# **Evaluating Systems to Reduce Road Improvement Impacts on Mountain Streams**

North Carolina Department of Transportation  
PROJECT AUTHORIZATION NO. HWY- 2005-05

Subject: Review Comments On Draft Final Report  
N. C. State Research Project for BMP's on DOT Roadways

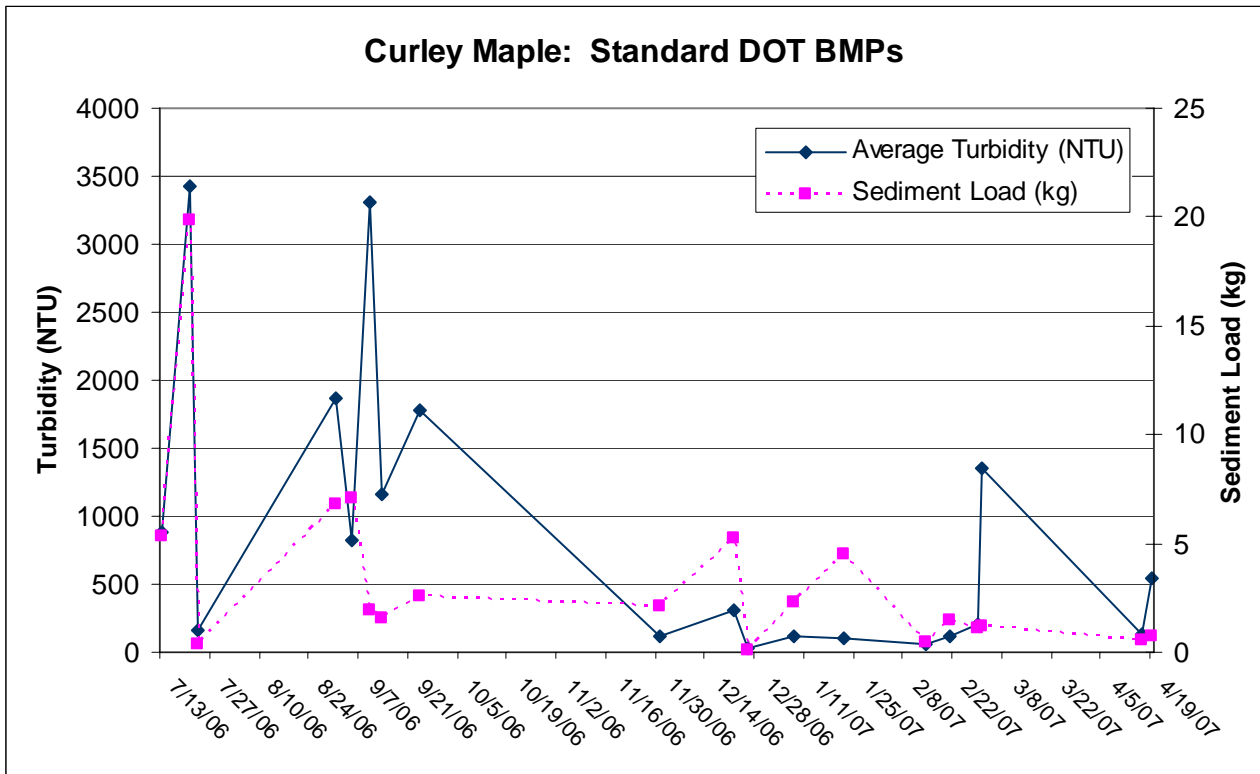
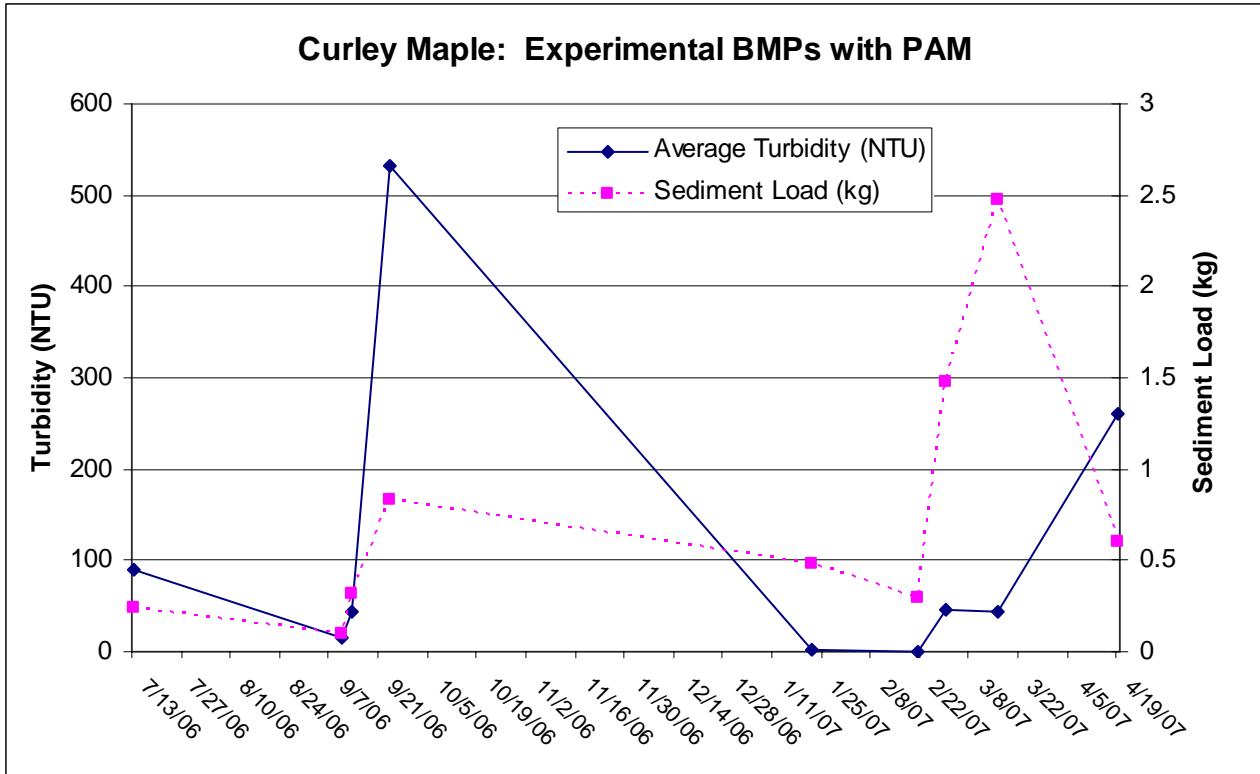
3. How effective are the new BMP's on high output short duration rainfall events? As an example one to three inches of rainfall that falls within a couple of hours. This type of rainfall event has been occurring this summer across the mountains.

3) In the course of this project there were very few high output and short duration rainfall events as defined as one to three inches over a couple of hours. However, that type of storm event was recorded for the 6/27/06 and 8/30/06 sampling events and suggests that the experimental BMPs more than adequately hold up under those intense conditions, especially as compared to the standard BMPs (see Tables 10, 11, and 12 for further details).
